DEPARTMENT OF THE ARMY  
WILMINGTON DISTRICT, CORPS OF ENGINEERS

Action ID No. 2008-00528  
Mr. Richard W. Hancock, P.E., Manager  
Project Development and Environmental Analysis Unit  
1598 Mail Service Center  
Raleigh, North Carolina 27699-1598

Project Name/ TIP Project No.: R-2514 B Date: 1-27-16

RE: Refinement of CAMA Major Development Permit No. 43-15 (TIP No. R-2514B, C, and D),  
Improvements to US 17 in Onslow and Craven County.

STATE OF NORTH CAROLINA  
 DEPARTMENT OF TRANSPORTATION  
 RALEIGH  
**GENERAL DRAWING**  
 BRIDGE OVER HIGGINS BRANCH  
 ON PROPOSED US 17 BYPASS  
 BETWEEN SR 1331 AND SR 1116  
 (LEFT LANE)

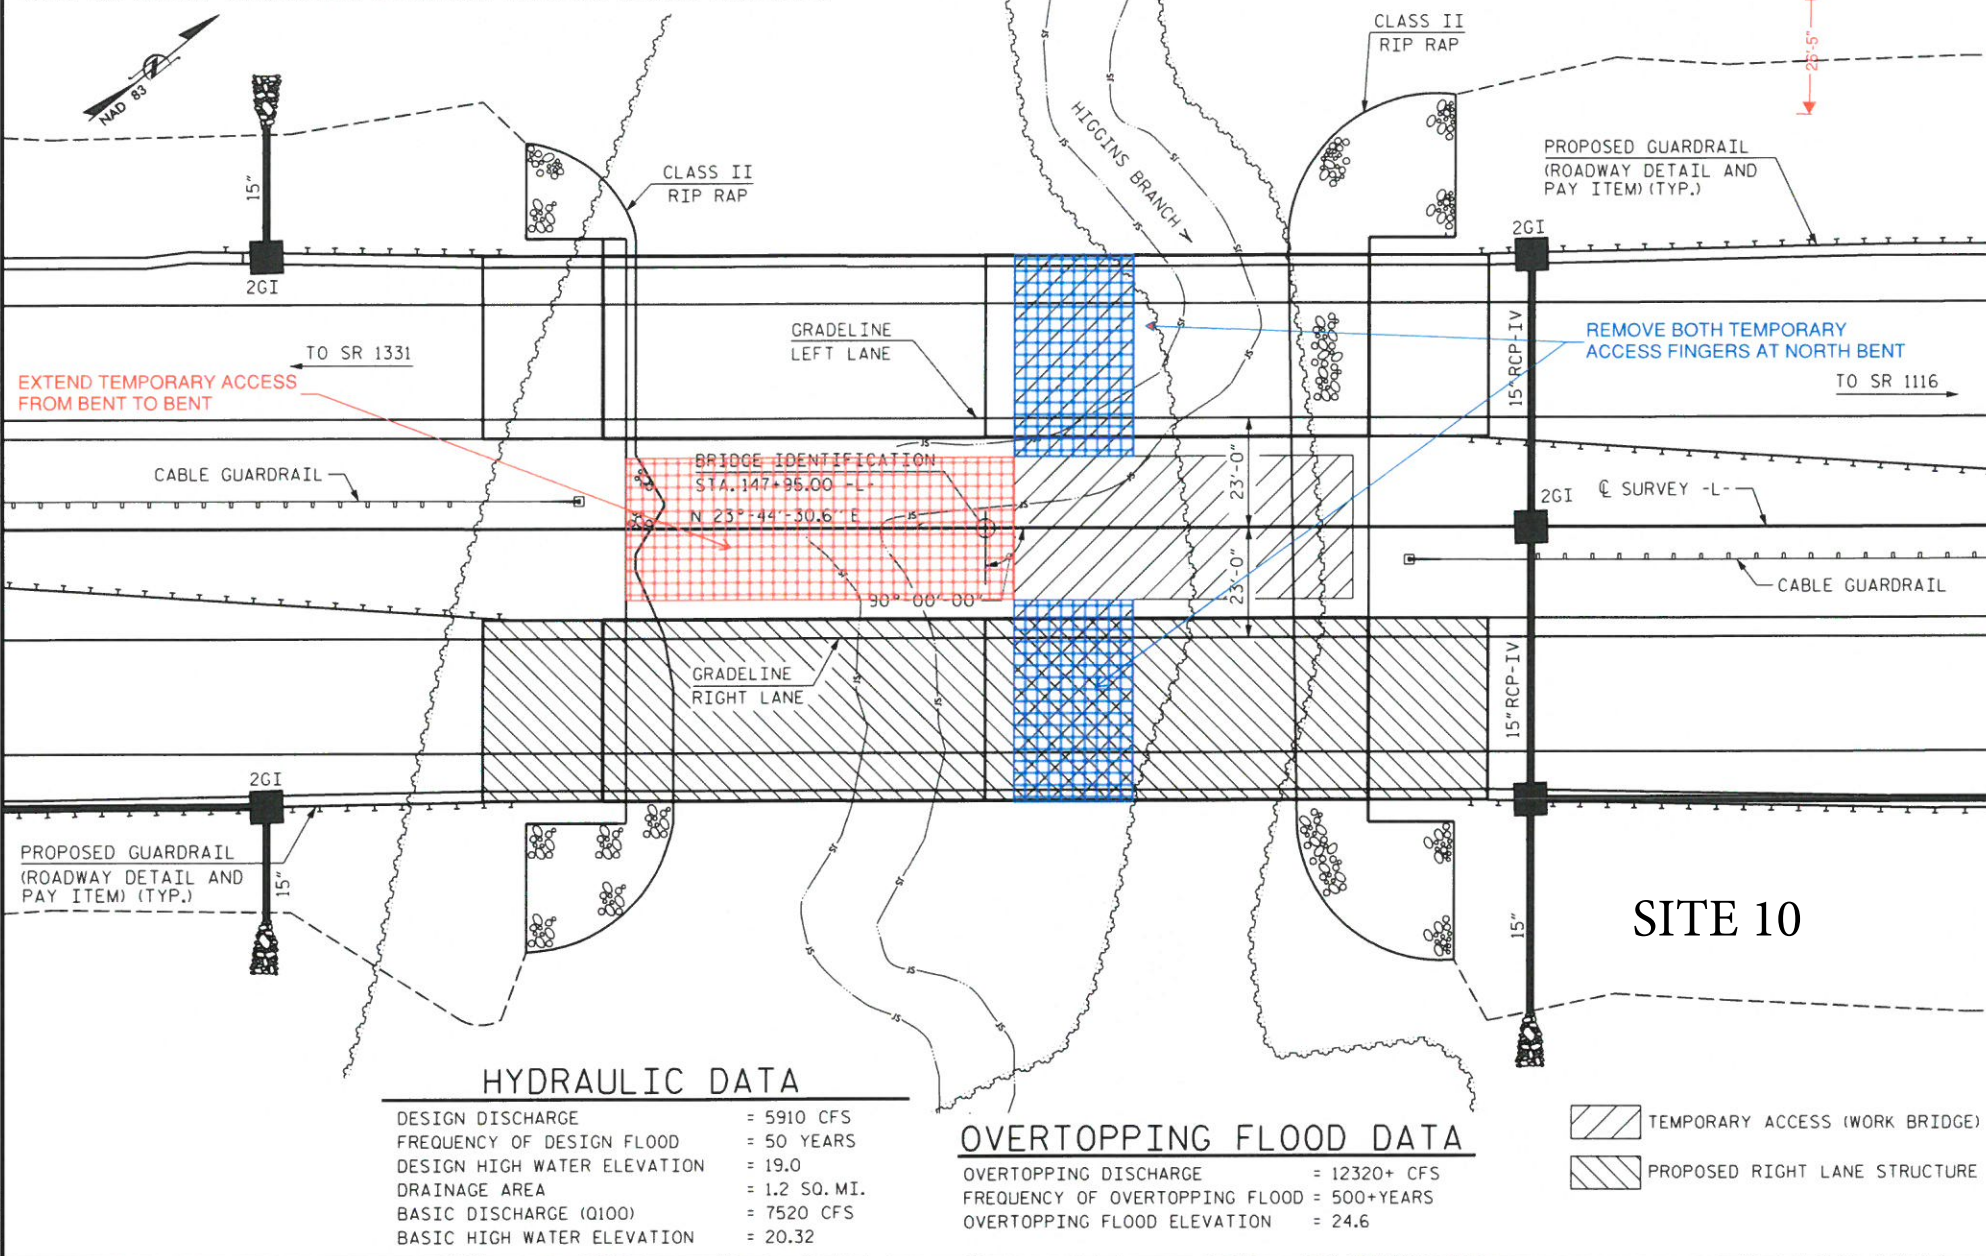
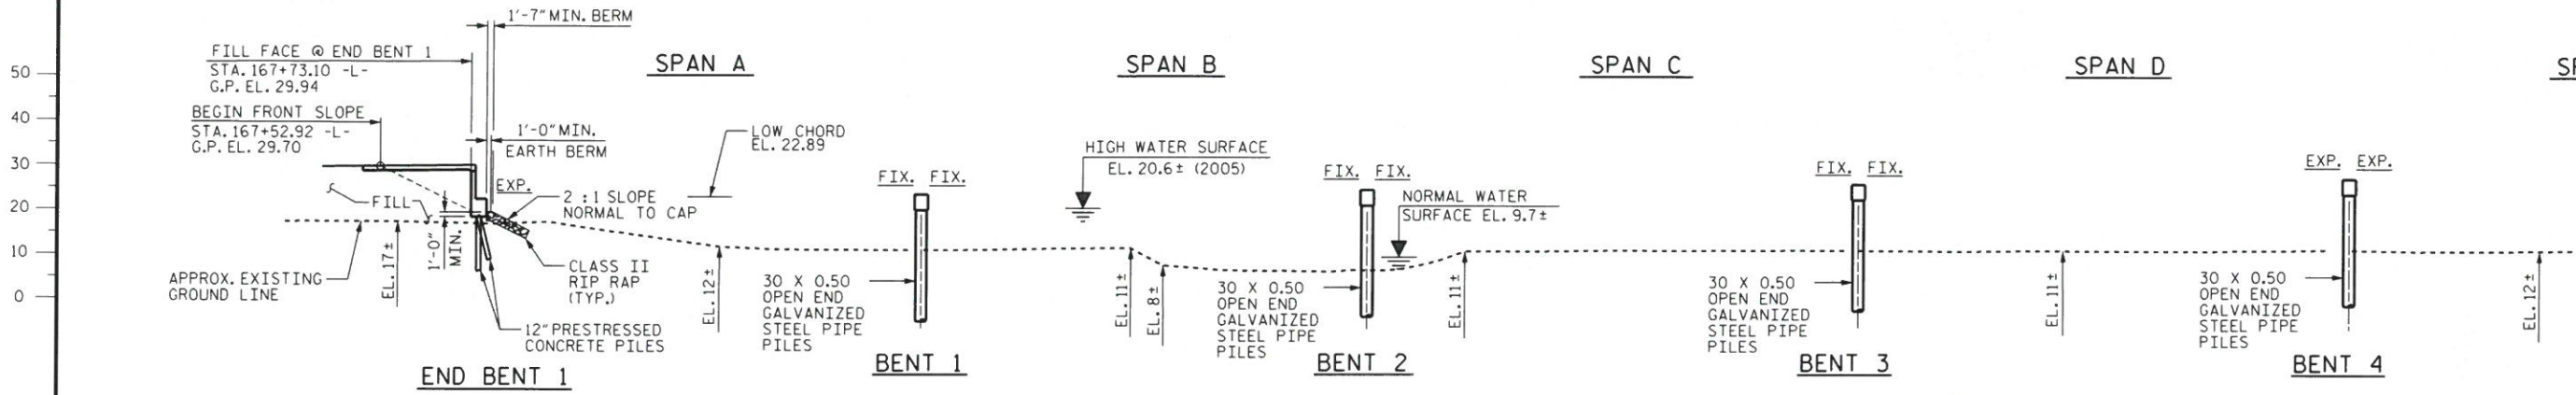
1). Site 10- Structures 2 and 3:

This permit modification requests temporary access between structures 2 & 3 at Sta. 147+95+00 -L-, be modified as depicted in the submitted plan sheet. The proposed design removes the fingers at bent 1 of the proposed permanent bridge and extends the work trestle over Higgins Branch connecting the two sides. The additional area requested will have a trestle with a maximum width of 30 ft and a minimum low steel elevation as the proposed permanent bridge. The environmental impact area for this location will decrease in size. The impacted area breakdown is as follows using 30 inch diameter steel pile at 35 ft bent spacing:

- Impact disturbed by trestle columns in non-permitted area: 44.18 sqft
- Total area disturbed by trestle columns: 132.5 sqft (27 columns)
- Temporary impacts due to temporary bridge bents in wetlands on Site 10 is <0.01 acre (435.6 sqft)

STATE OF NORTH CAROLINA  
 DEPARTMENT OF TRANSPORTATION  
 RALEIGH  
**GENERAL DRAWING**  
 FOR BRIDGE  
 ON PROPOSED US 17 BYPASS  
 OVER WHITE OAK RIVER  
 BETWEEN SR 1331 AND SR 1116  
 (LEFT LANE)

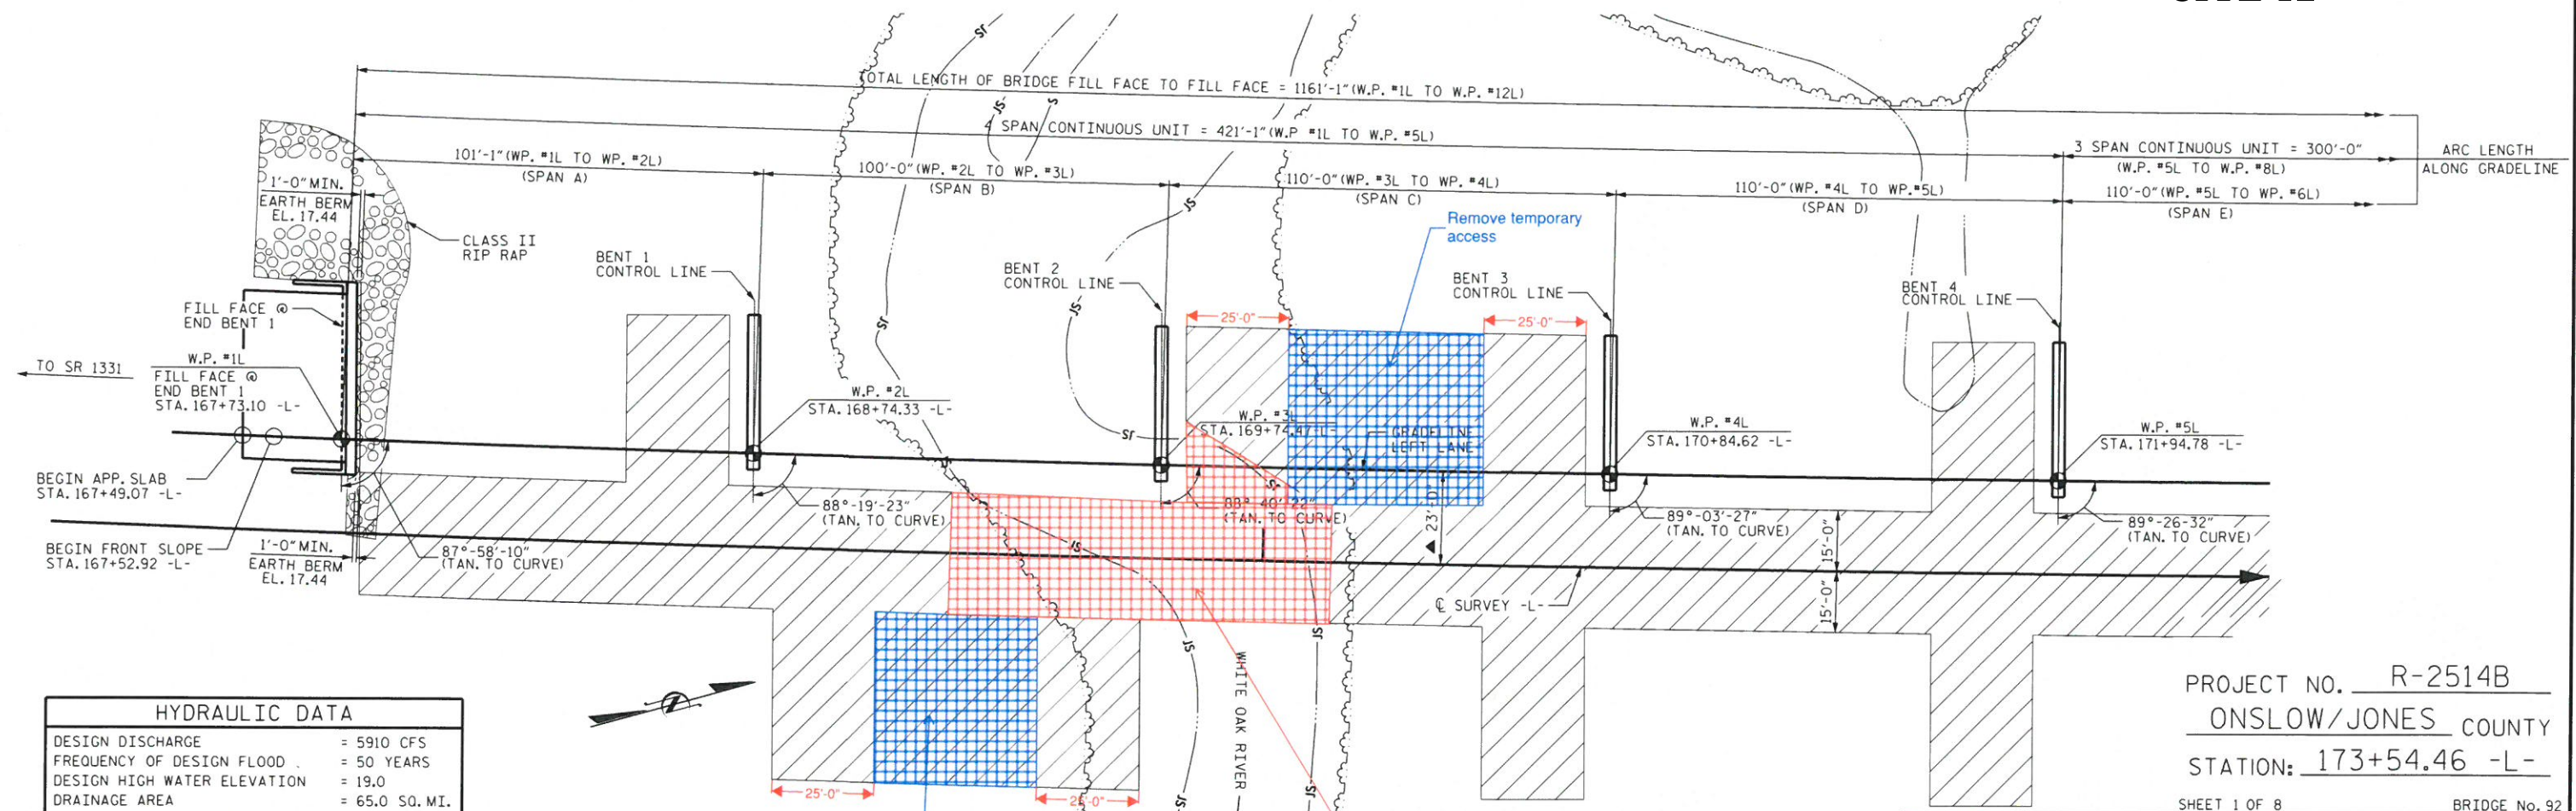
2). Site 12- Structures 4 and 5:

This permit modification requests temporary access between structures 4 & 5 at Sta. 173+54.46 -L-, as depicted in the submitted plan sheets. The modified design will remove part of the fingers at bent 2 of the permanent bridge and extend the work trestle over White Oak River connecting the two sides. The additional area requested will have a trestle with a maximum width of 30 ft and a minimum low steel elevation as the proposed permanent bridge and the existing US 17 bridge located downstream. The environmental impact area for this location will decrease in size. The impacted area breakdown is as follows using 30 inch diameter steel pile at 35 ft bent spacing:

- Impact disturbed by trestle columns in non-permitted area: 44 .18 sq.ft.
- Total area disturbed by trestle columns: 500.69 sq.ft. (102 columns)

- Temporary impacts due to temporary bridge bents in wetlands on Site 12 is <0.03 acre (1306.8 sq.ft.).
